December 2016
FL727A
NHTSA #16V-809

Subject: FCCC Motorhome Power Steering Hose Routing

**Models Affected: Specific Freightliner Custom Chassis XBR, XCL,
XCM, and XCR chassis equipped with Cummins ISL engines,
and manufactured January 1, 2016, through October 13, 2016.**

Fig. 1, Power Steering Hose with P-Clip (body removed for clarity)

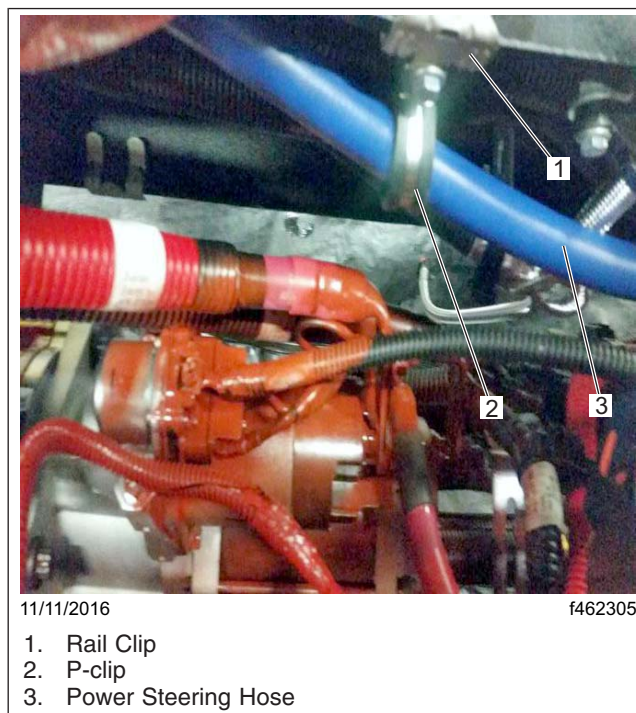
On certain motorhome chassis, the high pressure power steering hose may be routed with inadequate clearance between the hose and a power stud on the starter motor. This may cause the hose to chafe against the power stud on the starter, potentially leading to arcing and, in addition, may cause loss of fluid, short circuit, and melting. Electrical arcing in the presence of leaking power steering fluid can increase the risk of a fire.

The high pressure power steering hoses will be rerouted to provide adequate clearance from the starter stud.

1. Install a rail clip on the top flange of the frame rail, just above the starter.
2. Using a P-clip, bolt, nut, and washer, secure the power steering hose on the rail clip. See [Fig. 1](#). Tighten the nut 72 lbf-in (813 N-cm).
3. For additional security, install tie bands around the hose to the harness near the frame rail within 18 inches (46 cm) of the P-clip.
4. Clean a spot on the base label (Form WAR259). Write the recall number, FL727, on a completion sticker (Form WAR260), and attach it to the base label.
